RIDER TRANSMISSION CLUTCH & BRAKE ADJUSTMENT

(R8B.94 Page 1 of 3)

Serial Numbers 1000-MY'95

This Bulletin Replaces R8.94 & R8A.94

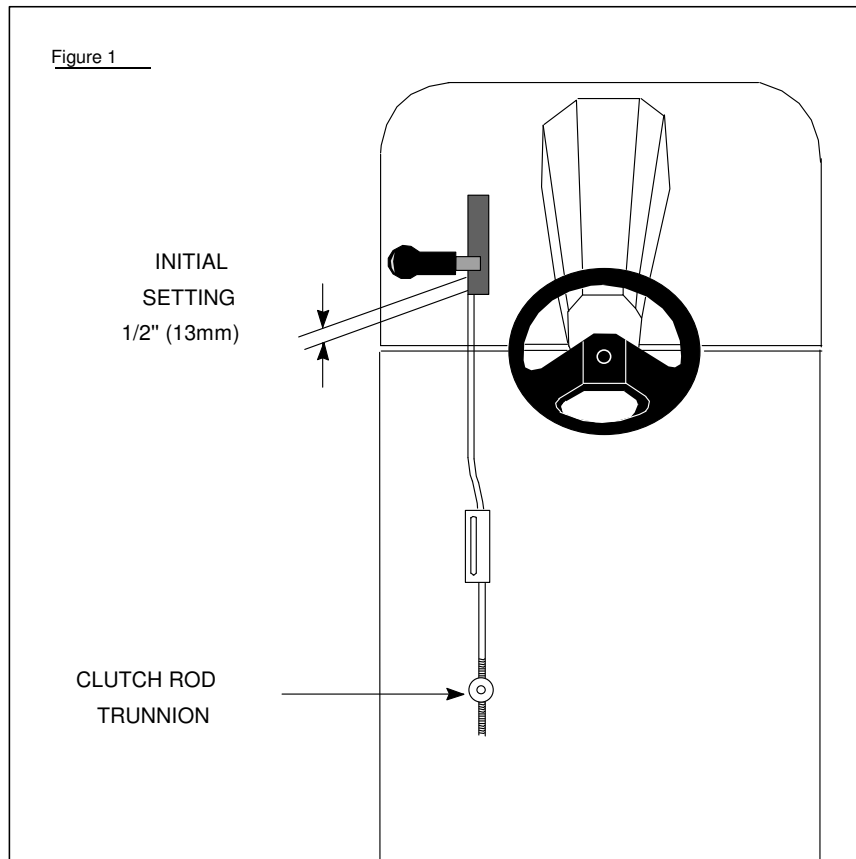
The Rider transmission system must first be checked to ascertain whether the following parts have been fitted :

- | | |

| 1. Belt keeper on clutch plate stud | 30-1331-00 |
| 2. Transaxle belt pin | 32-7200-00 |
| 3. Small belt keeper (on double PTO pulley) | 30-1329-00 |
| 4. Clutching plate | 32-7201-01 |
| 5. 'Waisted' engine pulley | 18-3142-01 |
| 6. Clutch jockey pulley (no longer a 'V') | 20-8115-00 |

If these parts have not been fitted then these must be obtained from the Countax Spares Department before the adjustments can be carried out. They must then be fitted with reference to Figure 1 of this bulletin. **A new drive belt should be fitted if these adjustments are required.**
